UNITED STATES
NUCLEAR REGULATORY COMMISSION
REGION I
631 PARK AVENUE
KING OF PRUSSIA, PENNSYLVANIA 19106

License No. 37-11438-02
Docket No. 030-13111
Control No. 107892

This is in reference to your application dated September 29, 1987, to renew License No. 37-11438-02. In order to continue our review, we need the following questions answered:

QUARTERLY SEALED SOURCE INVENTORY AND AREA SURVEY

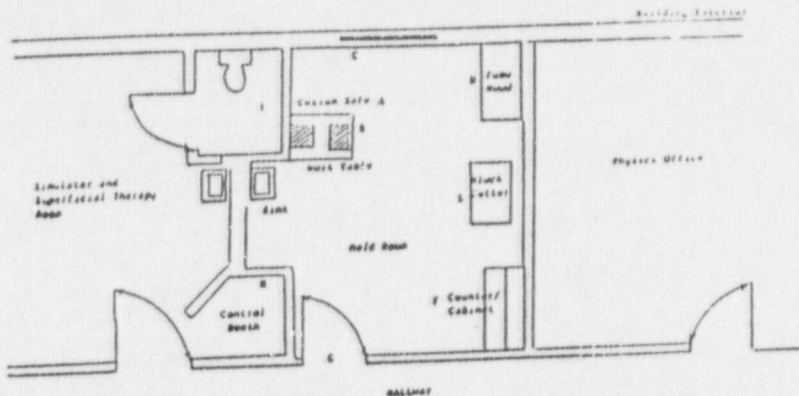
- (b) Submit copies of the forms you will use to record the results of your quarterly sealed source and brachytherapy source inventory and of the dose rate surveys performed in all areas where such sources are stored.
- (c) Submit an outline of the precautions you will follow for handling these sources. Include a description of the procedures and equipment used to transport them.
7. Confirm that all waste, with a half-life of 65 days or less, will be held for decay a minimum of 10 half-lives prior to surveying and disposal (if background).
